Comments on Proposals O-9354 and Z-9355

We are the couple who own and live at 185 Forest Hill Ave. In reviewing the proposed official plan and zoning amendment O-9354/Z-9355 (257-263 Springbank Dr.), the associated site plan, the London Plan, and Zoning By-law No. Z.-1, we have come to the conclusion that the proposed 6-story, 38-unit, mid-rise, apartment complex is simply too big for these lots and not a good fit for the character of the area.

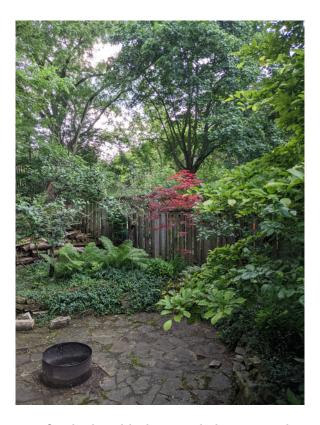
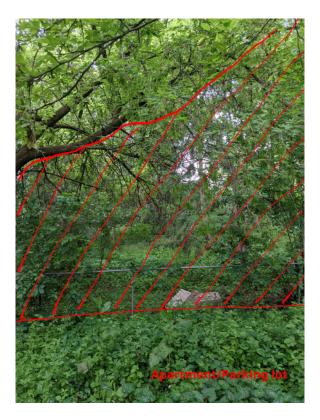
Contrary to all the aforementioned bits of the London Plan, the proposed development will not preserve and enhance the character of the neighbourhood and buffer and mitigate its impact on those of us with adjacent lots. Rather it will strip us of the very thing we cherish. Our privacy and the complete nature immersion will be gone if much of the treescape that towers over our single-story home to the south is replaced with six

stories of apartment building staring down on us. The south ground view in the back half of our yard will be the extended north-west portion of the parking lot. The same will be true on the residential property to the west of the sites. Our neighbours, whose property forms the north-east corner cut out of the amalgamated lots, will be entirely surrounded on side and back by apartment and parking lot.

Figure 10: Site plan overlay with R9-7 setback regulations (Zoning By-law Table 13.3)

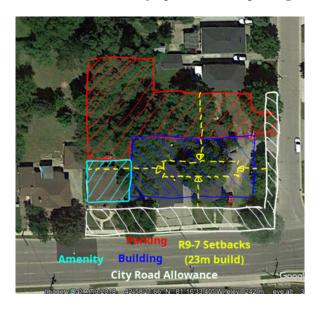
While it isn't yet clear how the Urban Corridor type place will be recognized with respect to zoning requirements (part of why approving this now under the Urban Corridor vision is jumping the gun), the proposal is to for the current R9-7 designation. R9-7 is the highest density form of the R9 medium and higher density designations. This is to be contrasted with the aforementioned Urban Corridor vision of place appropriate moderate levels of intensity, with lesser levels along the primarily residential segments lacking large floor space. [826,840] Nonetheless, we have tabulated the setback requirements given in Table 13.3 of the city's Zoning By-law for an R9-7 zoning abutting a R1 or R2 residential zone in the following table and overlaid them with the site plan onto satellite imagery.

yard depth	minimum	proposed
front	10m	$0.5 \mathrm{m}$
exterior side	$10 \mathrm{m}$	$2.3 \mathrm{m}$
rear	23m	$15.0 \mathrm{m}$
interior side	23m	$13.8 \mathrm{m}$

Clearly, there are significant issues. Even with the proposed extremely reduced front and exterior side setbacks, the 1:1 height to setback ratio required on the rear and interior sides does not leave enough space for the building. Further, while the Urban Corridor place type does specify that buildings are to be situated close to the front lot to assist with rear setback, accepting the level of reduction proposed in this case will create future issues. If the Urban Corridor street vision for Springbank Dr. is to be realized (it has been classified for widening), the city will needs its full road allowance, and this will result in six stories of balconies with virtually no setback over the future pedestrian zone.[371,372,841,1737] It also seems doubtful that the R9 requirement for 30% landscaped open space is being met.
